FALLING LEAF SUBDIVISION, UNIT TWO

APPLICATION NUMBER 9 DATE May 3, 2007

REQUEST Subdivision

DETAIL SITE PLAN

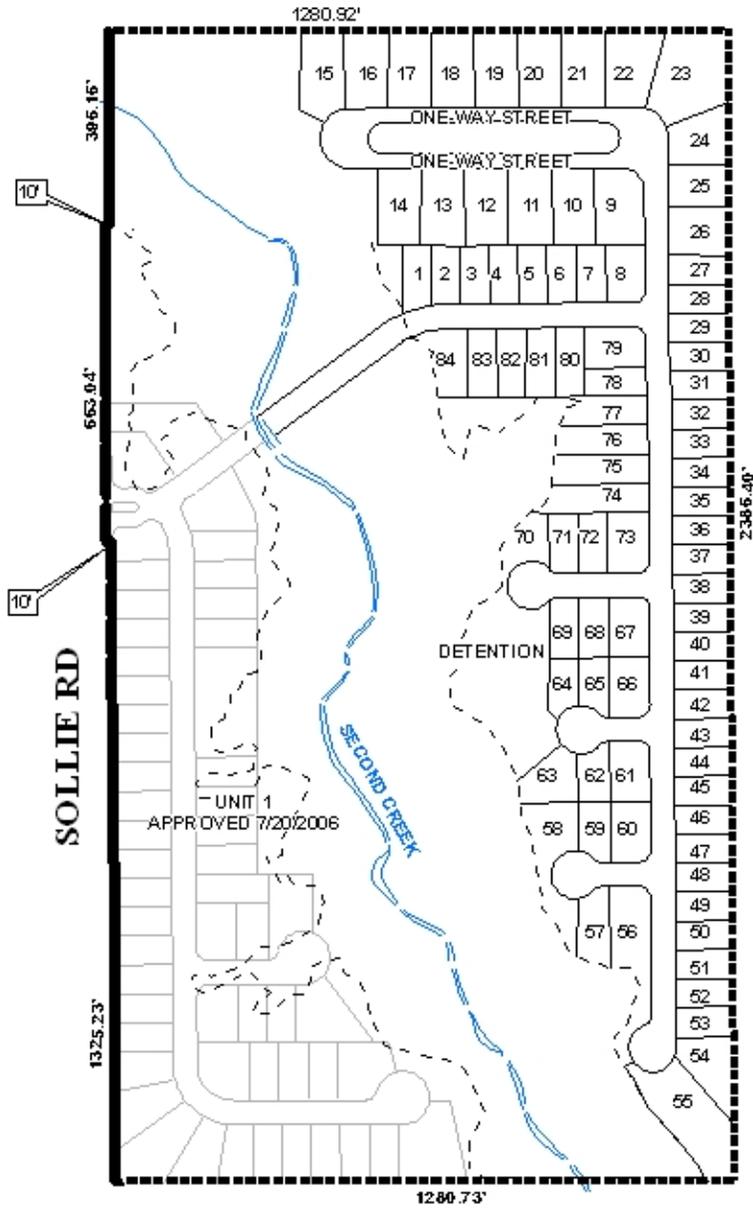
Additionally, since Lots 8, 9, 56, 60, 61, 66, 67, 73, and 79 are corner lots, a note should be placed on the Final Plat stating they are limited to one curb-cut each with the size, design and located to be determined by Traffic Engineering. Labeling of each lot with its size in square feet, or provision of a table on the plat with the same information is also requested.

result in only one point of access to Sollie Road, the plat does not provide any future street stubs to the adjacent undeveloped properties to the North and East, to allow for future development, as well as allowing for an additional access point to Sollie Road when the adjacent property is developed.

The requirements for street-stubs are based upon Section V.B.1. of the Subdivision Regulations, which states: "The street layout shall also provide for the future projection into unsubdivided lands adjoining of a sufficient number of streets to provide convenient circulation." The parcel East of the site is approximately 60± acres, while the parcel North of the site is approximately 95± acres. All adjacent parcels are currently undeveloped; however, the trend of this area is towards new residential subdivisions. The size of the parcels to the East and North of the site are such as to likely be the subject of future subdivision applications, hence the provision of two street-stubs to the East and one street stub to the North in the vicinity of Lots 15-20 should be required.

It appears that each lot meets the minimum size requirements for developments with access to public water and sewer. Due to the size of the proposed development, it is requested that the applicant revise the preliminary plat to provide the size of each lot in square feet on the plat, either as a table or as a label for each individual lot.

Several areas are shown on the preliminary plat along the Second Creek and between the one-way streets that should be labeled as common area, thus a note should be placed on the Final Plat stating that maintenance of the common area will be the responsibility of the property owners.

- 1) the placement of a note on the Final Plat stating that Lots 8, 9, 56, 60, 61, 66, 67, 73, and 79 are corner lots be limited to one curb cut with the size, design and location to be approved by Traffic Engineering;

- 2) labeling of each lot with its size in square feet, or provision of a table on the plat with the same information;
- 3) placement of a note on the plat stating that approval of all applicable federal, state and local agencies is required prior to the signing of the Final Plat;

- 4) the provision of two street-stub to the East and one street stub to the North in the vicinity of Lots 15-20;
- 5) the labeling of all easements and Common Areas accompanied by a note on the Final Plat stating that maintenance of the common area will be the responsibility of the property owners;

- 6) the depiction of the 25-foot minimum building setback lines along Hillcrest Road and the new streets and
- 7) compliance with Engineering Comments Add note to plat stating that no work in the wetlands is allowed without a permit from the Corps of Engineers. Show limits of AE flood plain on plat. Show minimum finished floor elevation on each lot in the AE flood plain. Show location of storm water detention on plat. No fill is allowed in the AE flood plain without compensation. Any impact on the floodway must comply with FEMA regulations and City of Mobile Engineering Department standards. Any creek crossing must comply with AASHTO, Corps of Engineers, ADEM, FEMA, and City of Mobile Engineering Department requirements. No detention is allowed in the City of Mobile right of way or AE flood plain. Must comply with all storm water and flood control ordinances. Any work performed in the right of way will require a right of way permit).
